United States Patent and Trademark Office

APPLICATION NO.	FILING DATE	FIRST NAMED INVENTOR	ATTORNEY DOCKET NO.	CONFIRMATION NO.
10/824,229	04/14/2004	Keishi Inoue	09792909-5867	6345
26263	7590 11/02/2005		EXAM	INER
SONNENSO	CHEIN NATH & RO	DOAN, TH	DOAN, THERESA T	
P.O. BOX 06 WACKER DI	1080 RIVE STATION, SEAI	RS TOWER	ART UNIT	PAPER NUMBER
CHICAGO II 60606-1080			2814

DETAILED ACTION

FIG. 4

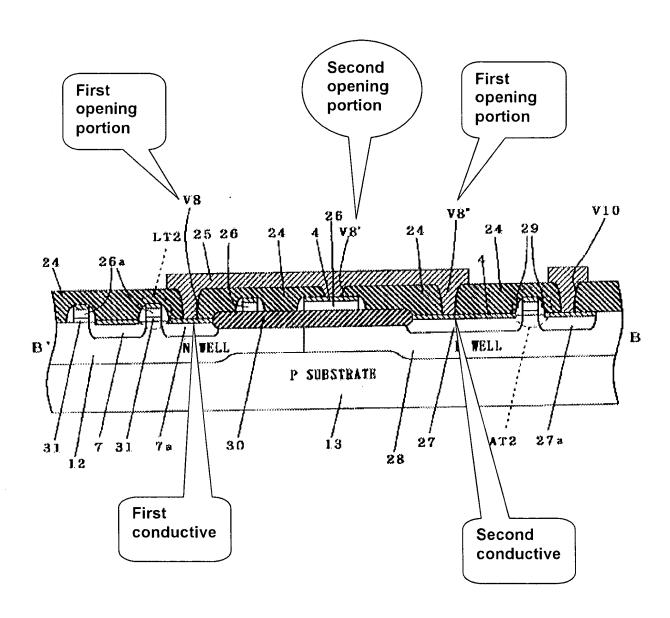
Regarding claim 1, Matsumoto (Fig. 4) discloses a semiconductor device comprising:

a first conductive layer 4 formed on the substrate 13 (See Fig. 4 Labeled by Examiner below and column 7, lines 18-21);

a second conductive layer 4 formed on the substrate 13 (also see Fig. 4 Labeled by Examiner below and column 7, lines 30-32) at a predetermined distance from the first conductive layer 4;

an insulation film 24 (column 7, line 38) formed on upper surfaces of the first conductive layer 4 and the second conductive layer 4 and having a plurality of first opening portions (V8/V8") (column 7, lines 41-43) to expose either the first conductive layer 4 or the second conductive layer 4 and one or more second opening portions V8' (column 7, lines 41-43) to expose neither the first conductive layer 4 formed at the first opening portion V8 nor second conductive layer 4 formed at the first opening portion V8"; and

a third conductive layer 25 (column 7, line 39) formed on an upper surface of the insulation film 24 (column 7, lines 38-39) in such a manner to fill up the first opening portions (V8/V8") and the second opening portions V8' for making electrical connection between the first conductive layer 4 and the second conductive layer 4 by way of the first opening portions (V8/V8");

wherein the second opening portions V8' are formed between a pair of the first opening portions (V8/V8") along the third conductive layer 25 (See Fig. 4 Labeled by the Examiner below).

Regarding claim 4, Matsumoto (Fig. 4) discloses a semiconductor device comprising: a substrate 13 (column 6, line 23); a first conductive layer 4 formed on the substrate 13 (column 7, lines 18-21); a second conductive layer 4 formed on the substrate 13 (column 7, lines 30-32) at a predetermined distance from the first conductive layer 4; an insulation film 24 formed on upper surfaces of the first conductive layer 4 and the second conductive layer 4 and having a plurality of opening portions (V8/V8") (column 7, lines 41-43) to expose one end portion of the first conductive layer 4 or of the second conductive layer 4; and a third conductive layer 25 formed on an upper surface of the insulation film 24 (column 7, lines 38-39) in such a manner to fill up the opening portions (V8/V8") for making electrical connection between the first conductive layer 4 and the second conductive layer 4 (See Fig. 4 above); wherein the third conductive layer 25 has a predetermined wiring length to maintain the connection, and has the electrical connection between the first conductive layer and the second conductive layer 4 at both ends of the third conductive layer 25 by way of the opening portions (V8/V8"). It is noted that where the claimed and prior art products are identical or substantially identical in structure or composition or are produced by identical or substantially identical processes, claimed properties or functions are presumed to be inherent. In re Best, 195 USPQ 430, 433 (CCPA 1977). Therefore, if the prior art teaches the identical structure, the properties applicant discloses and/or claims are necessarily present. In re Spada, 15 USPQ2d 1655, 1658 (Fed. Cir. 1990). In this case, the third conductive layer 25 would inherently have properties of maintaining the connection even if the length of the third conductive layer in a direction of longer length

changes due to thermal expansion or contraction because the forming of a second opening portion V8' between the first opening portions V8 and V8" would help to disperse the force resulting from the change in the wiring length of the third conductive layer 25.
